State of New Mexico  
Energy, Minerals and Natural Resources

SUNDRY NOTICES AND REPORTS ON WELLS  
(DO NOT USE THIS FORM FOR PROPOSALS TO DRILL OR TO DEEPEN OR PLUG BACK TO A DIFFERENT RESERVOIR. USE "APPLICATION FOR PERMIT" (FORM C-101) FOR SUCH PROPOSALS.)

BP America respectfully requests permission to T&A the Dakota portion of said well in order to clean up the Mesaverde reservoir.

**Well Name:** Best GC 1M – MV/DK  
**Date:** October 1, 2007  
**Repair Type:** Well Servicing  
**Location:** T32N-R10W-Sec21      **API #:** 30-045-<sup>32316</sup>~~2316~~  
**County:** San Juan  
**State:** New Mexico      **Engr:** Anne Fickinger  
**Horizon:** MV/DK      **ph** 505-326-9483  
**CO2 :**      **Cell :** 505-486-9249  
**H2S:** 0ppm 6-27-07

**PROPOSED**  
**Best GC 1M - MV/DK**  
 Sec 21, T32N, R10W  
 API # 30-045-32316

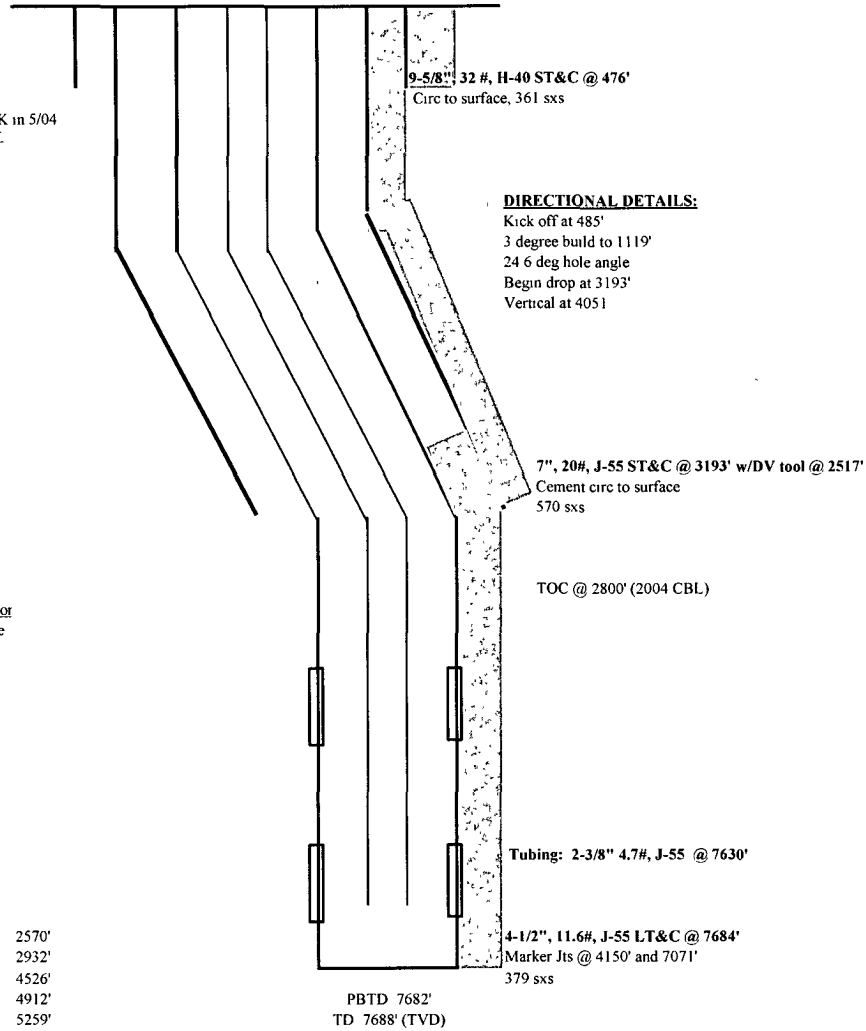
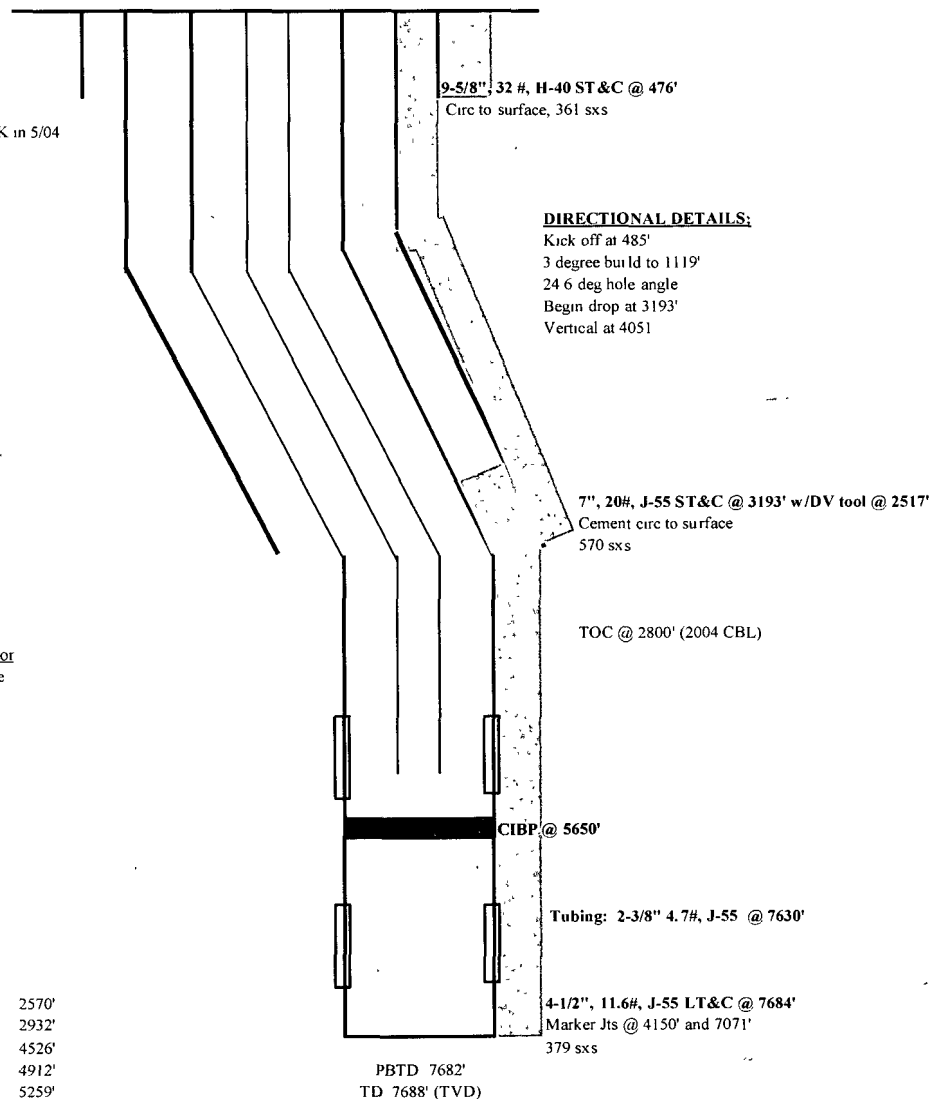
**Objective:** T&A Dakota formation and produce MV only.

12. POOH. Reference "Under Balanced Well Control Tripping Procedure".
13. RIH with CIBP and set at **5650'**.
14. TIH with (IF NEW IS NEEDED PLEASE NOTIFY ENGINEER) 2-3/8" tubing. Reference "Under Balanced Well Control Tripping Procedure".

15. Land 2-3/8" production tubing at +/- **5250'** (no deeper)'. Lock down hanger.
16. Pressure test tubing to 500 psi with air unit, make sure tubing spool valves are open. Care should be taken during pressure testing of the tubing due to potential problem caused if tubing parts close to surface or above the hanger. Check all casing string for pressure. The operations of removal of BOP and installation of wellhead will be performed under a dispensation for one (1) barrier on the backside.
